USB Live Oscilloscope	
Wolfgang Wieser 01/2006, 06/2006	
TITLE: MainBoard-r1a	
Document Number:	REV: 1a
Date: 6/18/2006 15:02:44	Sheet: 1/1

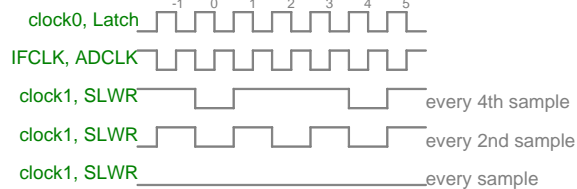
Difference to Rev.1:  
We can't use PKTEND as IO pin!
